Zoning Challenge and Appeal Form

Street Name Chambers Street

May 7, 2018

RE: Zoning Challenge
108 Chambers
Block 136, Lot 26
Job No: 121193519

Axonometric view of the building proposed in traditional land use colors

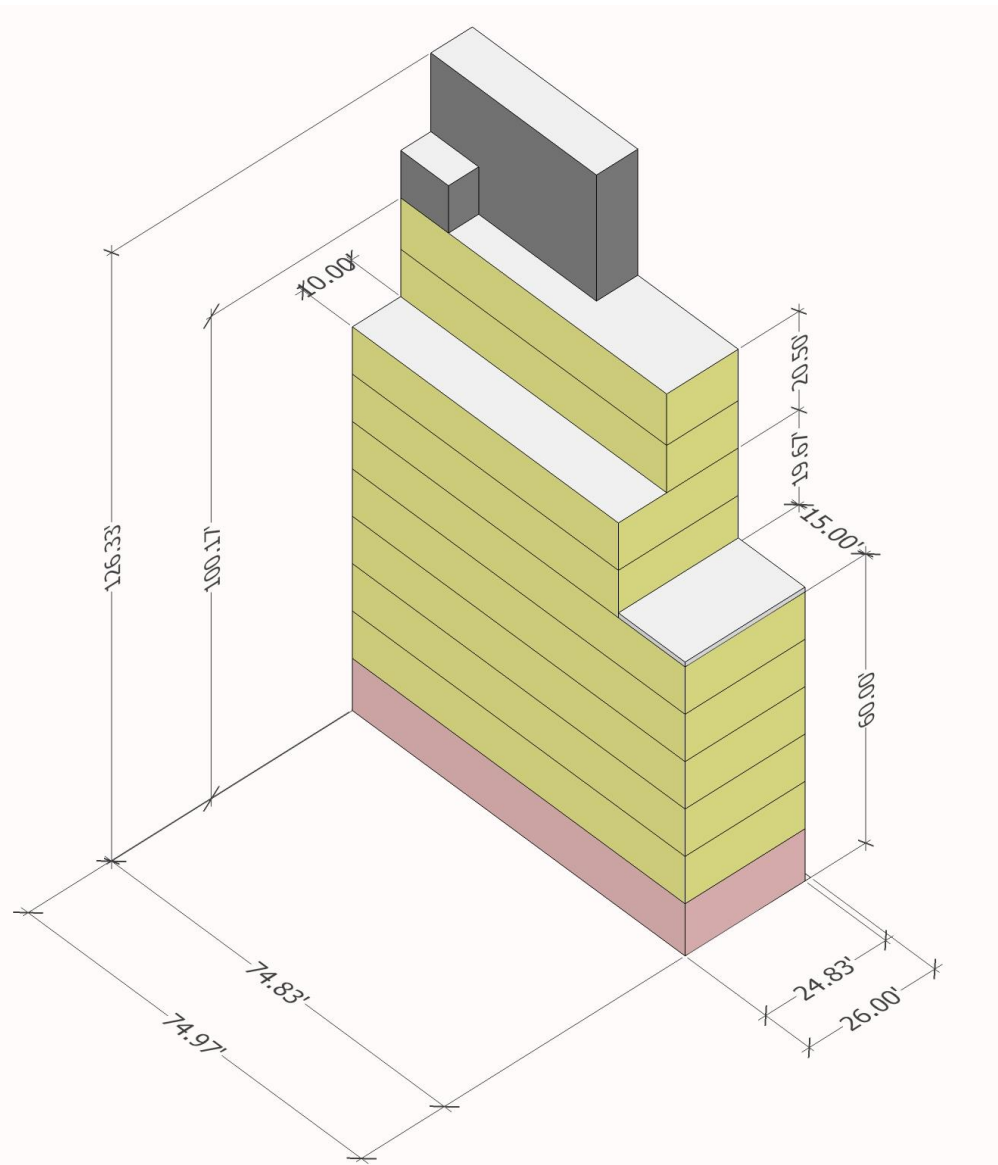
Since the building is only 24'10" wide along Chambers Street, the building proposed is height limited by the sliver rule 23-692, as modified by the Special District.

Axonometric view of proposed building (colored) shown with neighboring buildings. Dimensions from 3D LIDAR model or from ZD1.

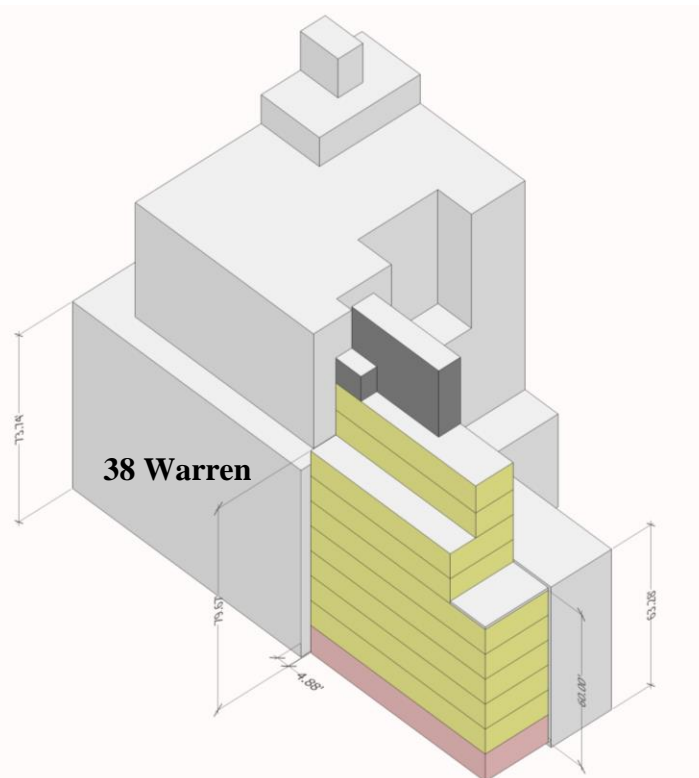
¹ The ground elevation of the new building was taken from the ZD1. Its ground elevation is substantially higher than both adjoining buildings. This means that, even though 110 Chambers is shown with a streetwall of 63 feet, it matches the streetwall of the proposed building at 60 feet.

The proposed building clearly does not match the base height of 38 Warren and the ZD1 claims this is not an adjoining building. This is not accurate, however, as 38 Warren adjoins the new development.

Detail ZD1 plan highlighting 38 Warren's fire escape

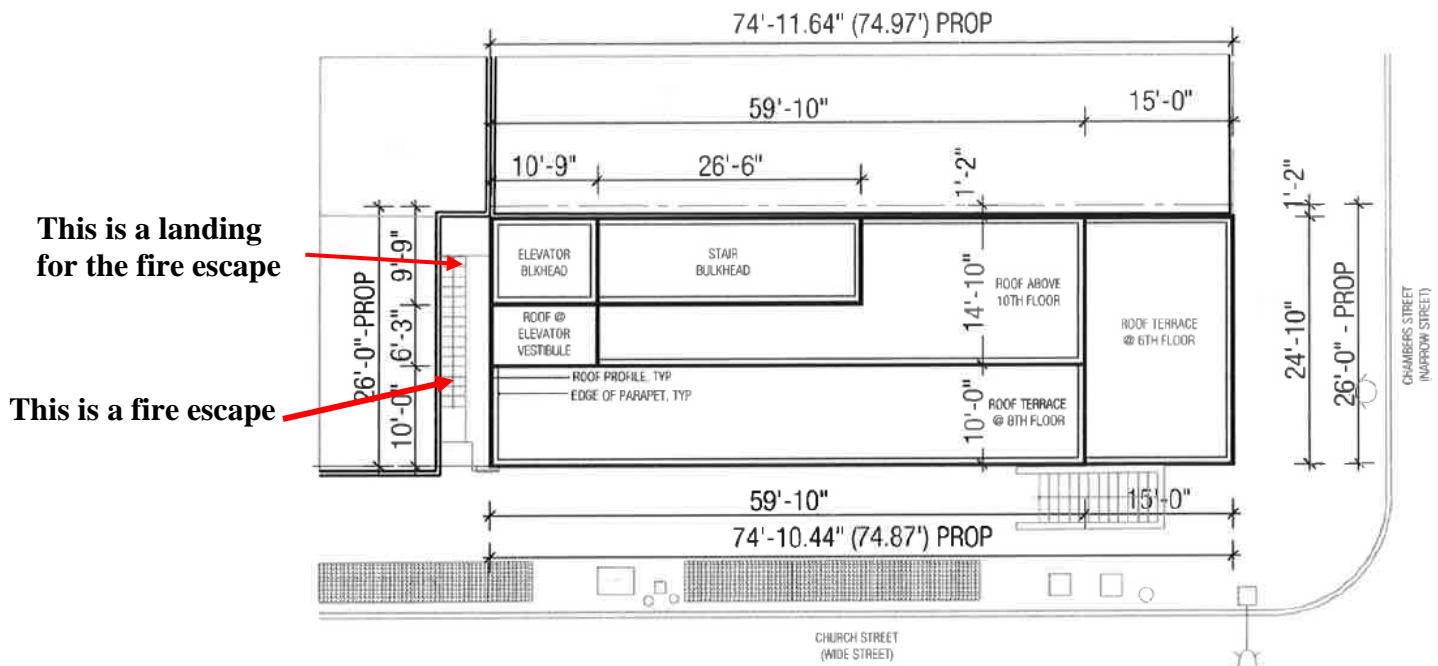
38 Warren has a fire escape that fills in the small non-complying space between the new building and the exterior building wall of 38 Warren. Fire escapes are permitted obstructions in outer courts, like this one.

Detail from page 8 of ZRD1 #51136 (249 East 62nd Street) showing how permitted obstructions and a seismic separation connect a new building to a lot line.

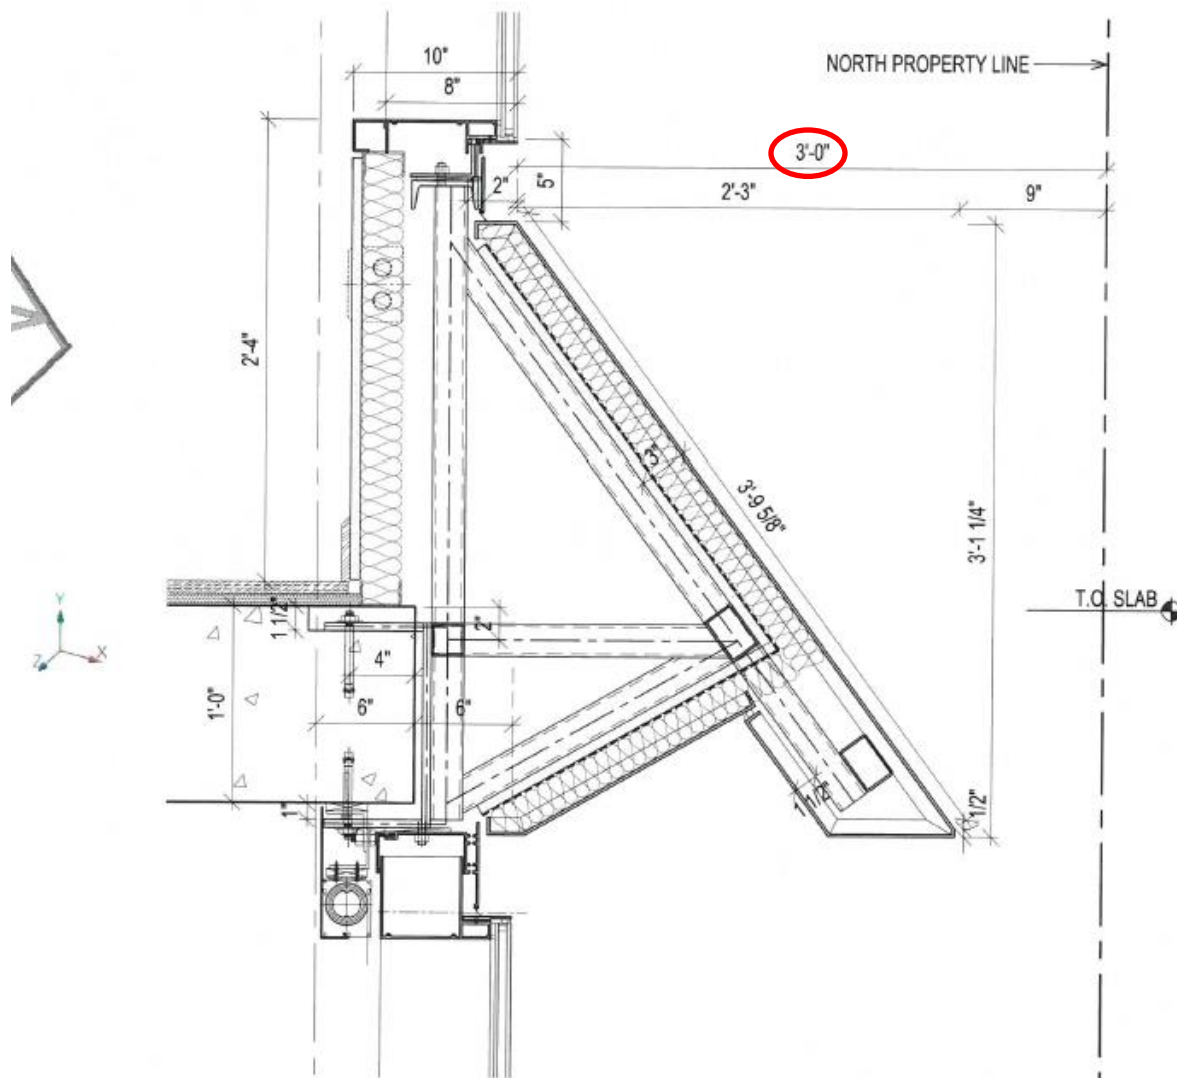
This diagram shows an open area 3 feet along the lot line. This is considered to comply because it consists of a permitted obstruction of 2'3" and a seismic separation of 9 inches. Despite all appearances, the Department concluded that this open area functions the same as a building for the purposes of abutting the lot line. A similar diagram can be made for the Warren Street building and its fire escape, most notably the fire escape landing. If the 62nd Street building abuts the

lot line, so does the Warren Street building and if the Warren Street building abuts, then it adjoins with 108 Chambers Street and the base heights must match.

SITE PLAN DIAGRAM

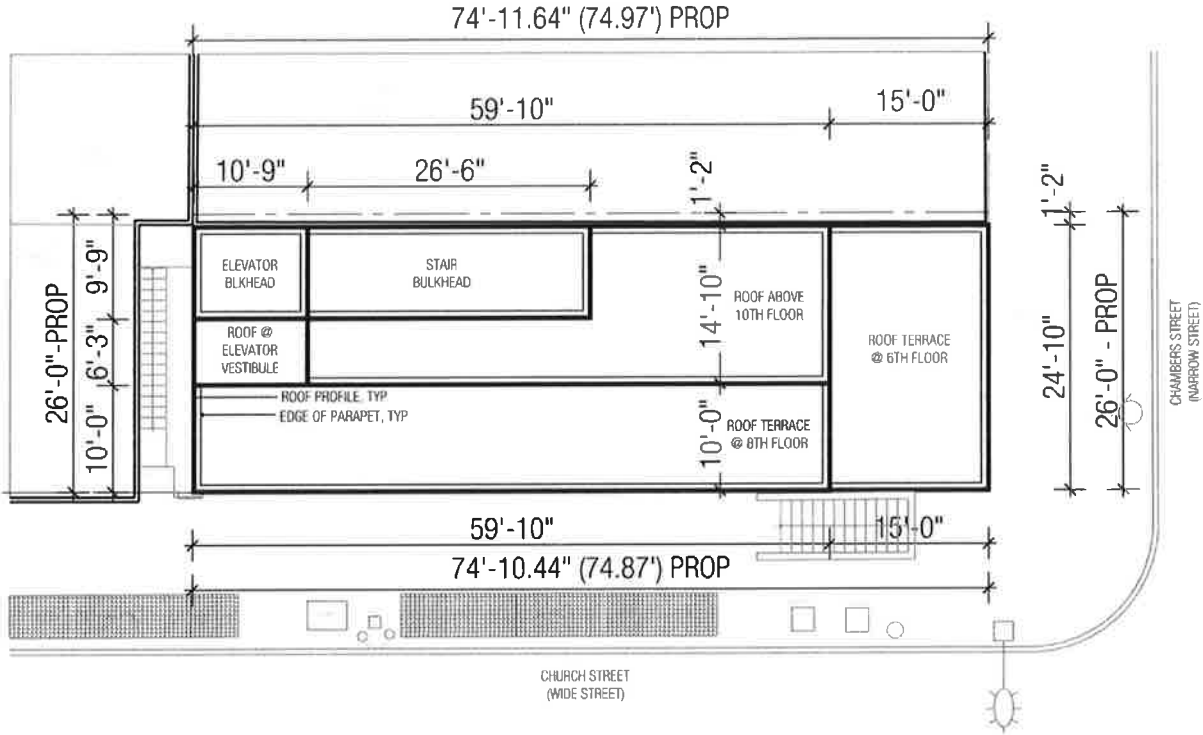
The plan shows that the building is proposed to be 24.83 feet wide on a lot that is 26 feet. There is a gap between the proposed building and its neighbor that is 14

Most of the gap is hidden behind the plywood and it appears to be the 14 inches shown in plan. ZR 23-462 (c) notes that while side yards are not required, if they are provided they need to be at least eight feet.

BC 1613.7 of the 2014 Building Code calls for 1 inch of seismic separation for each inch of height. This building is 126.33 feet to the top of the mechanicals, requiring a seismic separation of less than 3 inches but 14 inches is provided. This building, therefore, has a side yard of nearly 1 foot. It does not comply with 23-462(c).
